STAFF REPORT
COMMUNITY DEVELOPMENT DEPARTMENT

HEARING 5/25/2021
 DATE:
 TO: Mayor & City Council
 FROM: Joe Dodson, Associate Planner
 208-884-5533
 SUBJECT: H-2020-0122
 3175 N. Ten Mile Rezone

Request to rezone a 1.16 acre property from R-4 to the L-O zoning district commensurate with a provision within the Meridian Comprehensive Plan for the purpose of constructing an approximate 10,000 square foot office building in lieu of residential development and a Development Agreement Modification to replace the existing agreement (Inst. #111024535) and enter into a new agreement to develop the site consistent with the proposed development plan, by Mason & Associates.

C. Conceptual Building Elevations

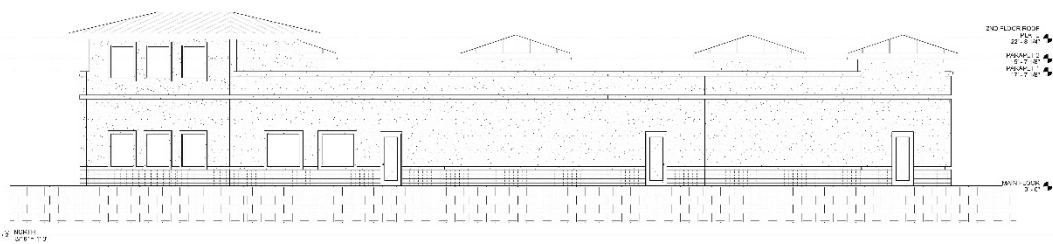
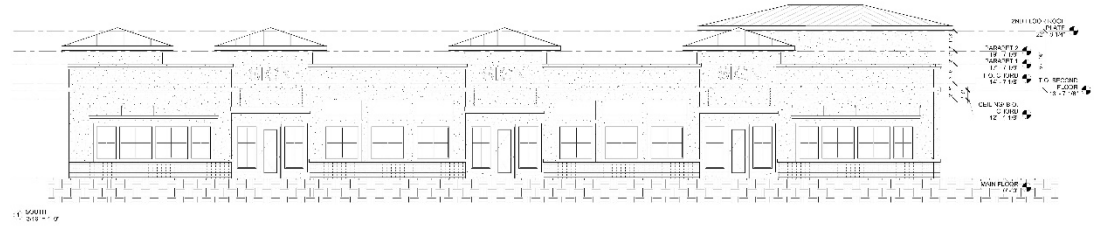
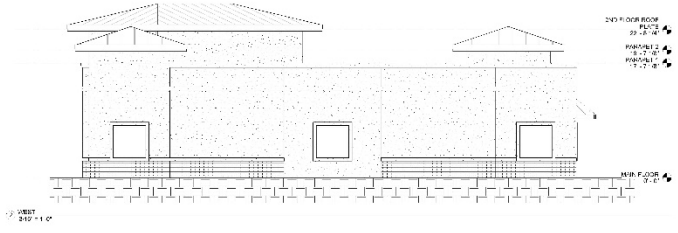
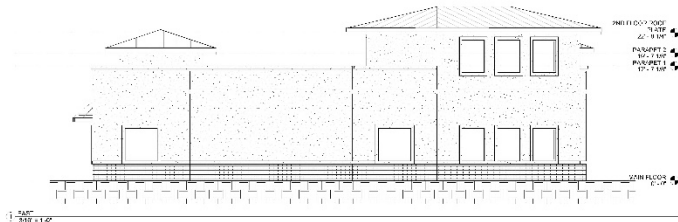
The Applicant submitted conceptual building elevations of the proposed single-story commercial building. The submitted elevations show a single story building approximately 22' to top of plate in the area of the building that directly abuts the intersection; this area is meant to hold the corner of this intersection. The remaining portions of the building are approximately 17.5' in height. Overall the building is shown with varying parapet heights, a stone material banding along the bottom of the building, horizontal wall modulation, and a main field material that appears to be stucco. The south facing elevation also shows awnings and windows nearly the length of the building lending itself to a modern storefront feel.

New commercial buildings require Administrative Design Review prior to building permit submittal so Staff will perform a more complete analysis of the proposed elevations at the time of that application submittal. Staff recommends the north facing elevation incorporate an additional field material to satisfy one or more of the architectural standards.
